**AGENDA
TECHNICAL REVIEW COMMITTEE
REGULAR MEETING
OCTOBER 24, 2024
10:00 AM
CITY HALL COMMISSION CHAMBERS
204 ASH STREET
FERNANDINA BEACH, FL 32034**

**AGENDA
TECHNICAL REVIEW COMMITTEE
REGULAR MEETING
AUGUST 22, 2024
10:00 AM
CITY HALL COMMISSION CHAMBERS
204 ASH STREET
FERNANDINA BEACH, FL 32034**

4.1 TRC 2024-0006 - SCOTT LOCKWOOD, AGENT FOR BAPTIST MEDICAL CENTERS, 1210 VINTAGE WAY

DARIUS PROPERTY
1520 SOUTH 14TH STREET
FERNANDINA BEACH, FLORIDA 32034

GEOMETRY
SITE PLAN

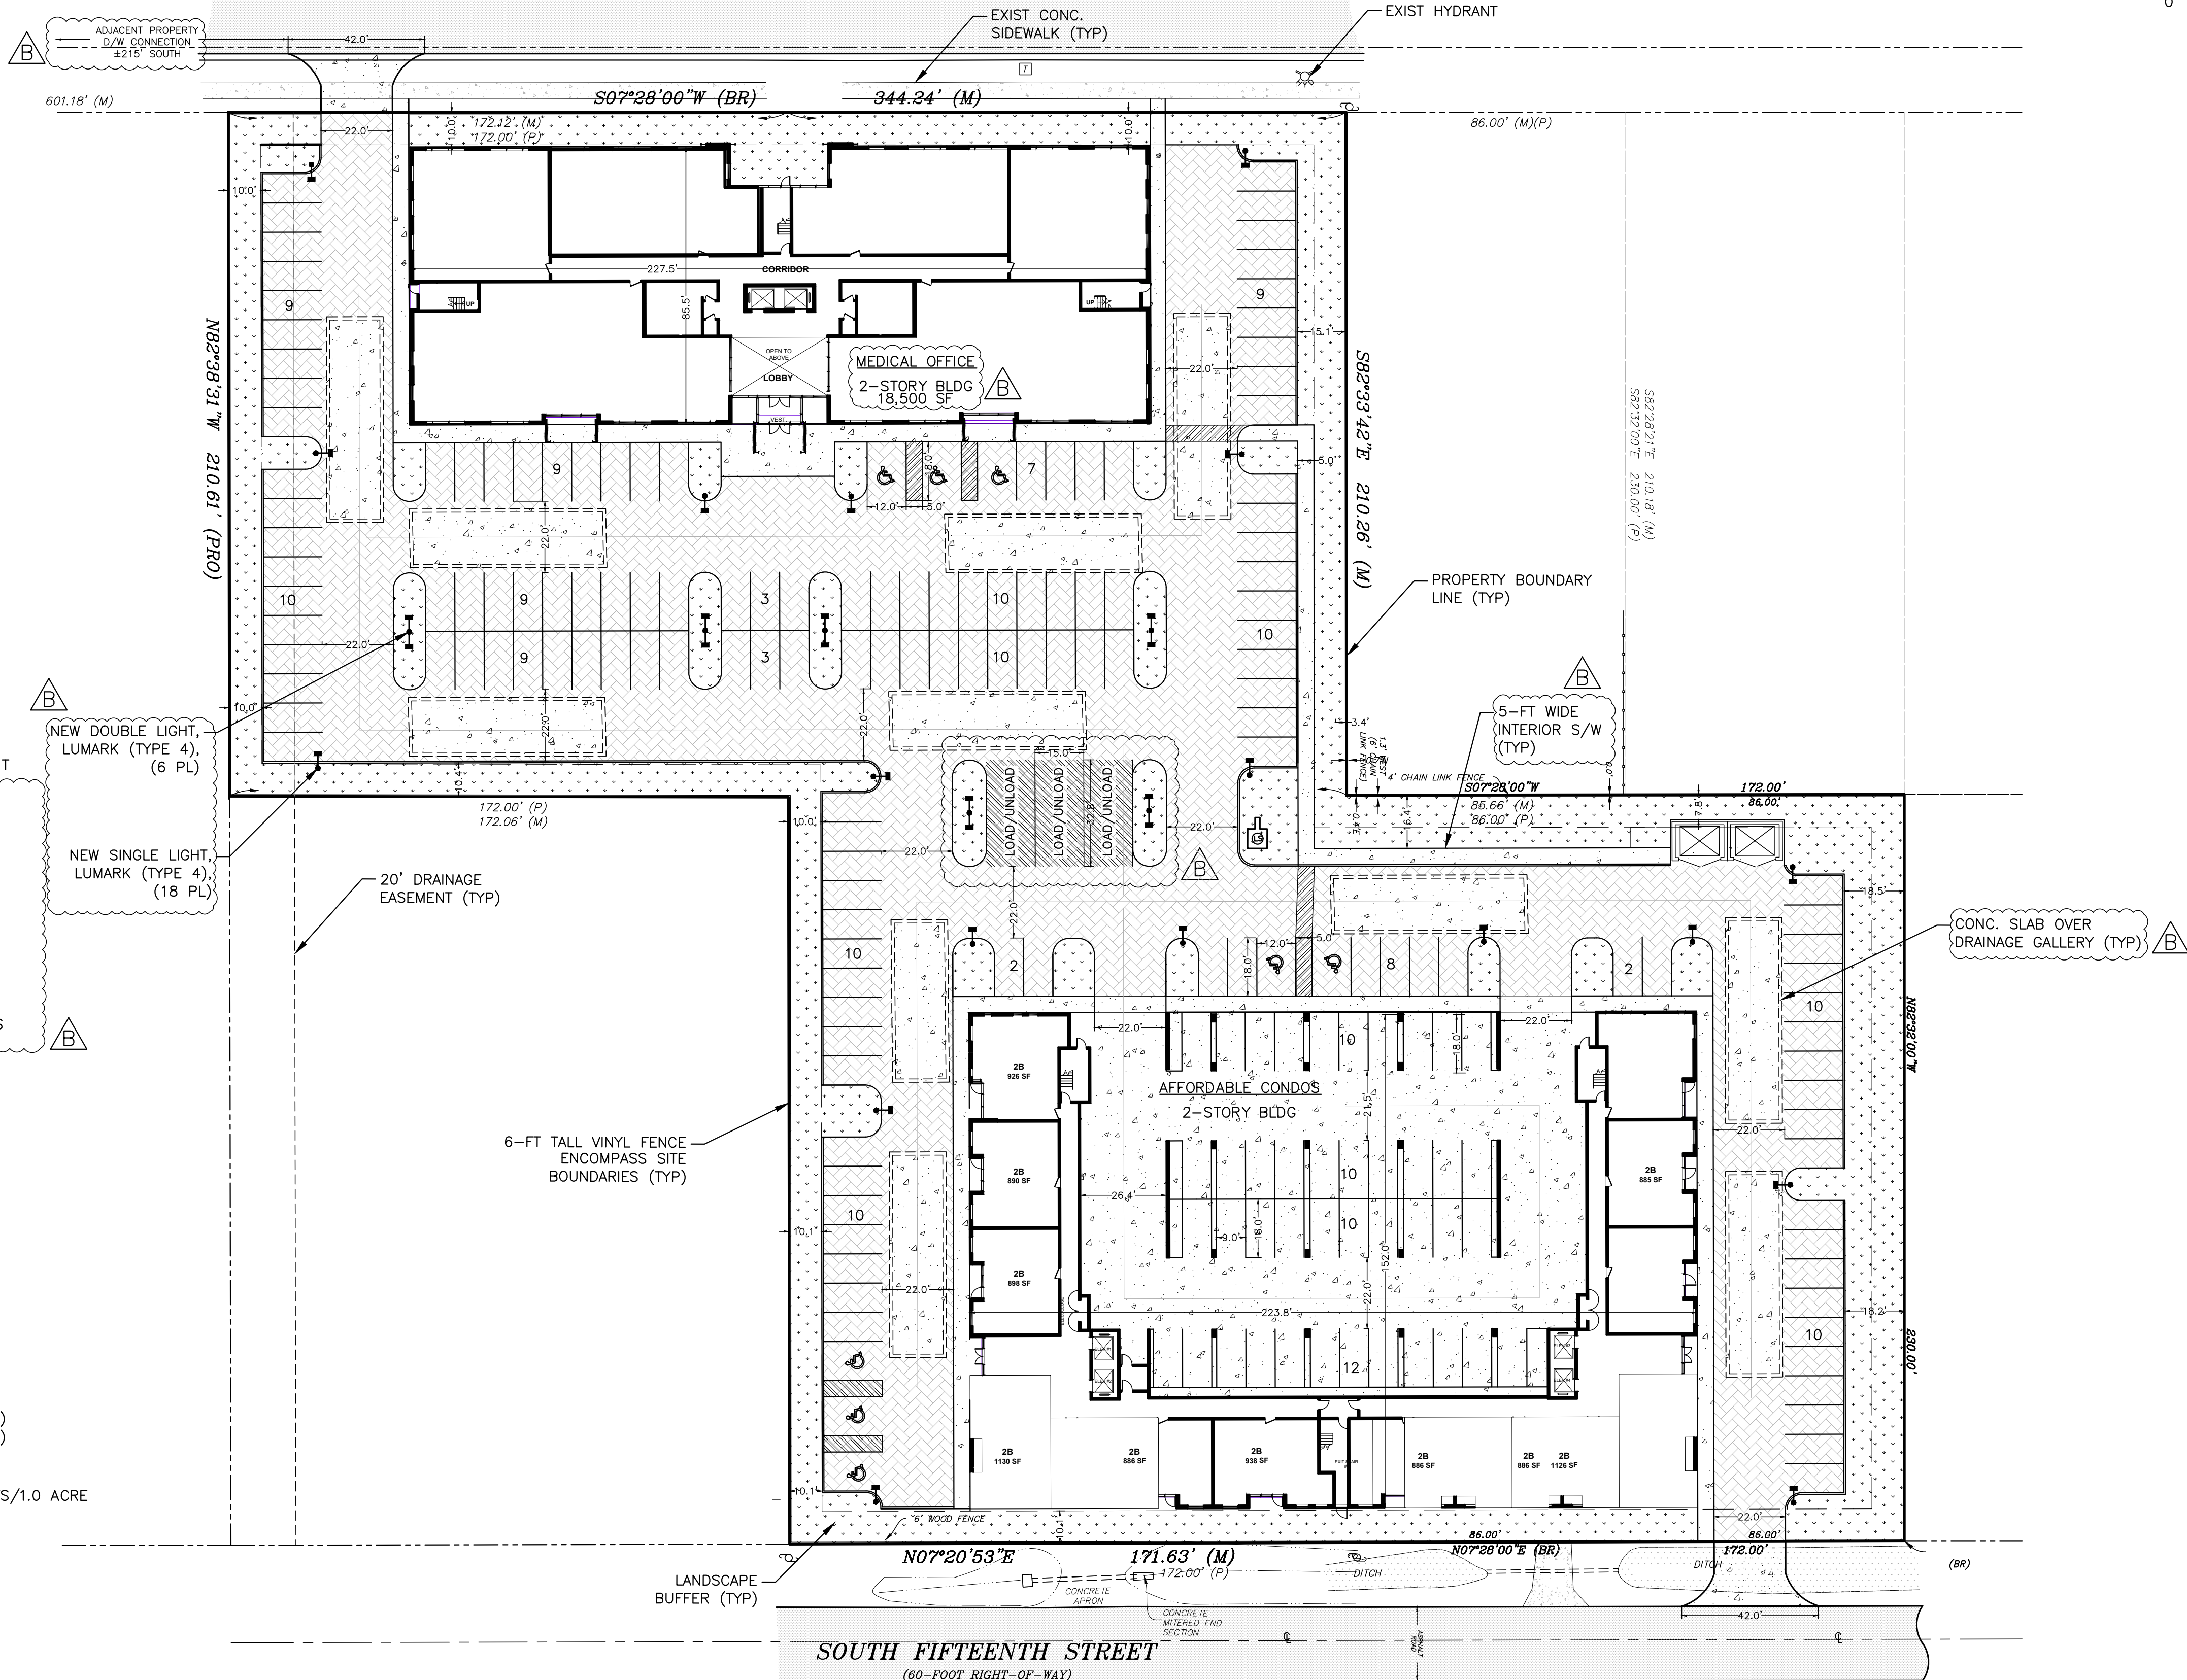
7.01.05(D) - Pedestrian circulation- please show location of crosswalks and sidewalks for entry into the complex with attention to safety for turning and through vehicles.

Additional crosswalks and sidewalks have been added to the site to add interconnectivity element. See sheet GE-1.

DRAINAGE PLAN

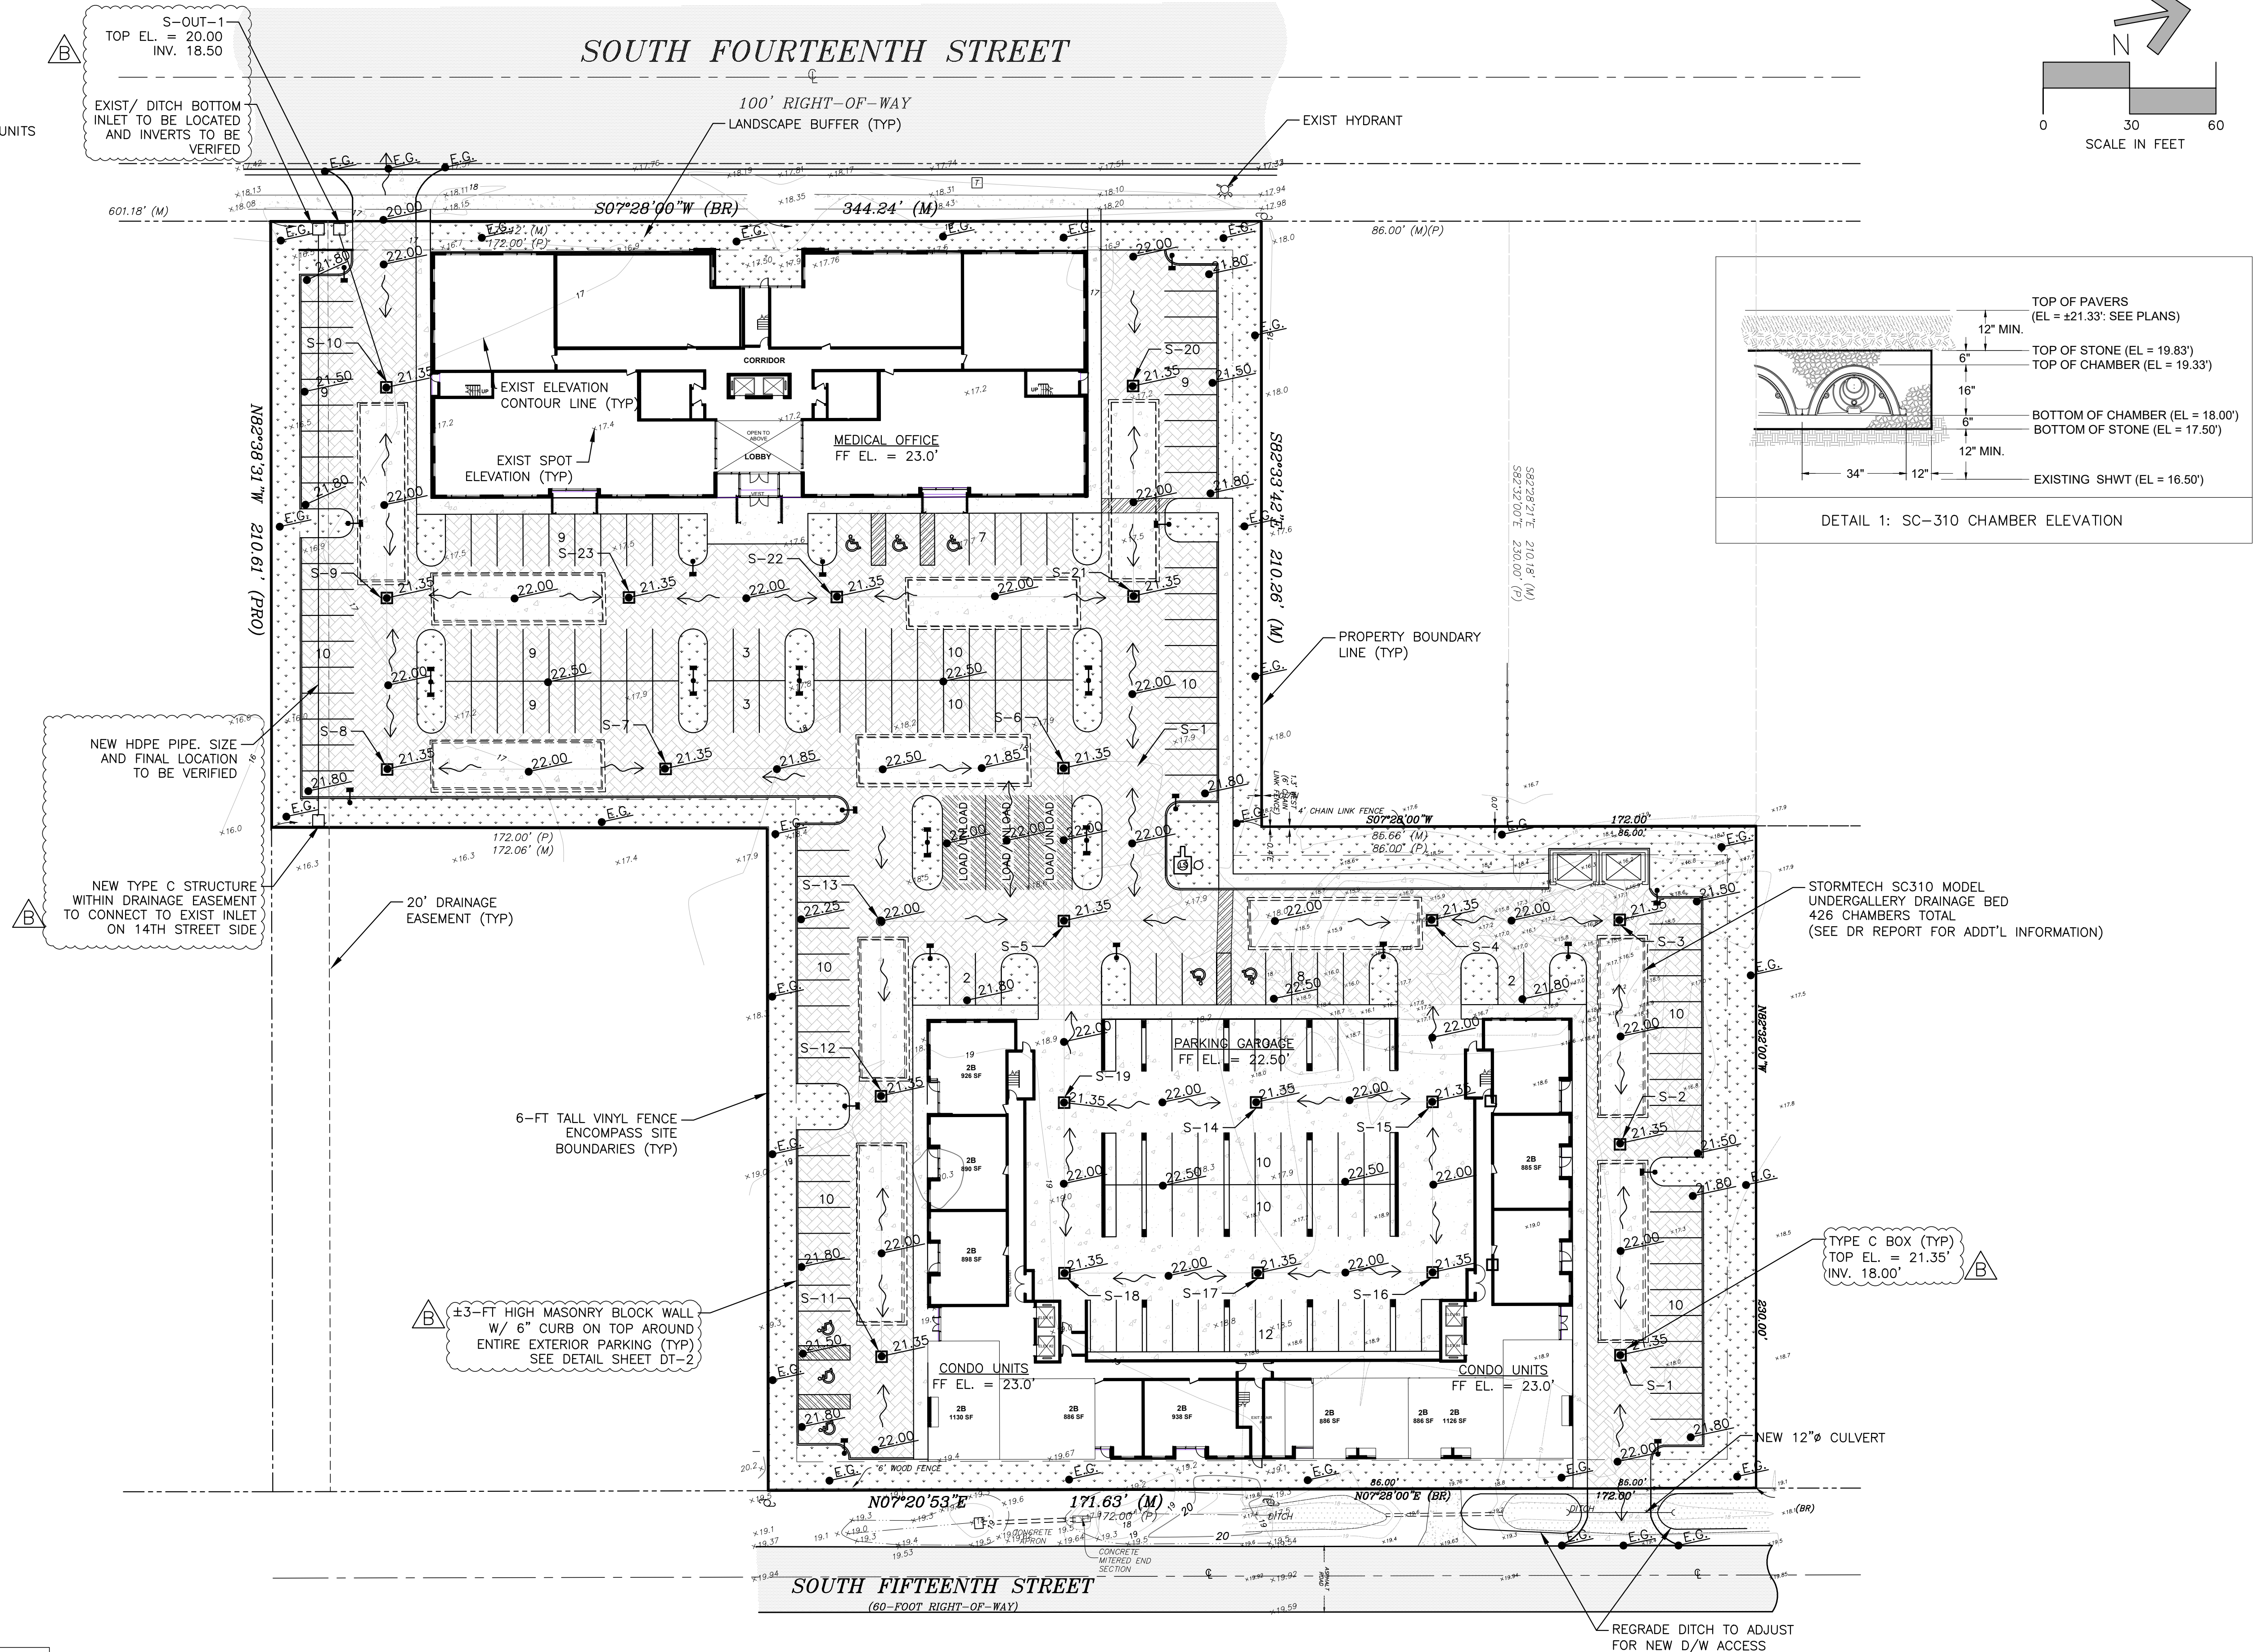
- Please provide the utility plans and details.
- Erosion control details and locations need to be included.
- Please provide a cross-section showing the transition to existing grade and retention walls.
- There is a ditch running on the Southern portion of the property in the 20' drainage easement. Please show plans to maintain the existing flow and provide who is going to maintain it.
- Please provide details and locations of the overflow weir.
- Please provide more information on the stormwater system.
- The Saturated Horizontal Hydraulic Conductivity does not match the geo report.

There is an existing ditch bottom inlet on the 14th street of the drainage easement. The plan is to connect this existing inlet to a new inlet on the other side of the easement to maintain hydraulic conductivity. The existing invert is to be located. See sheet DR-1 for additional notes on plan.

A detail for the outfall structure has been added to sheet DT-2. See sheet DR-1 for location of structure on site.

DETAIL 2
TREE STAKING PLAN

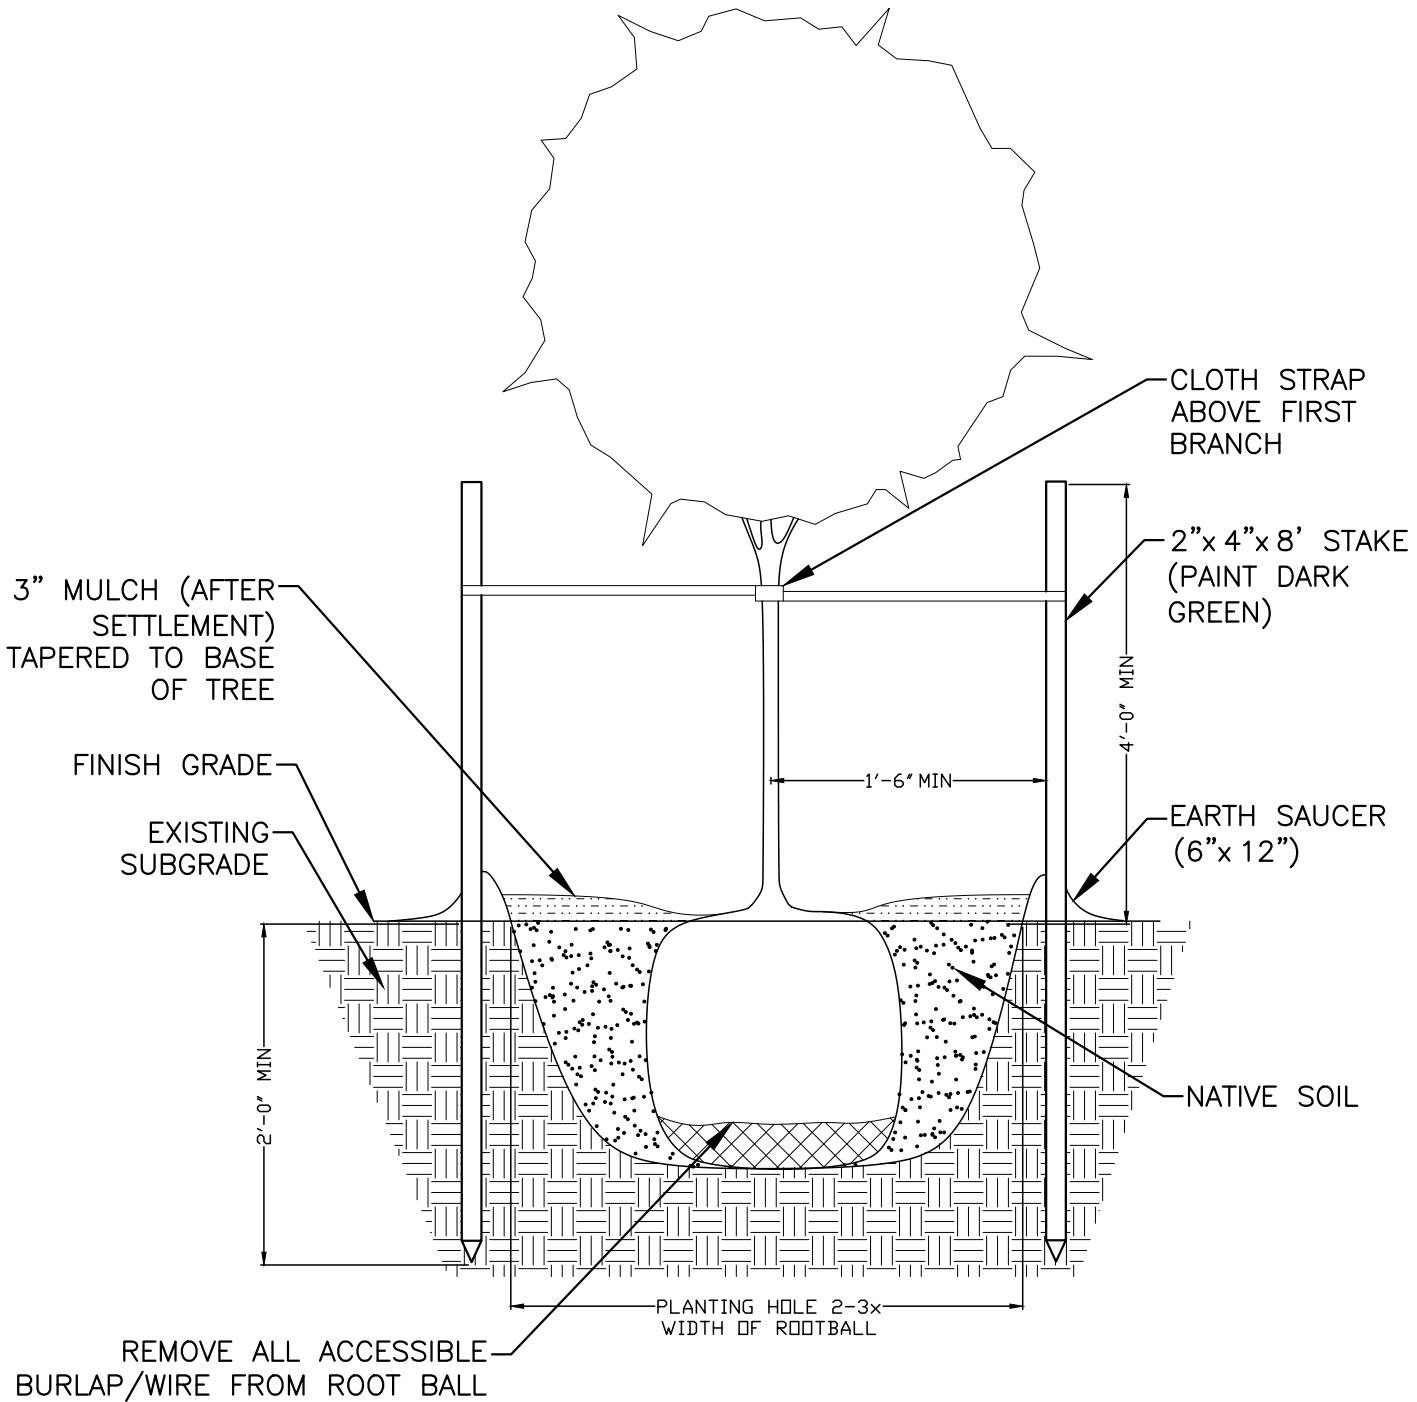
Please provide the ISA arborist information and clarification of the rating system used to determine health conditions.

Please see sheet LS-2 for the tree health rating system. The full arborist report is attached along with this submittal as well.
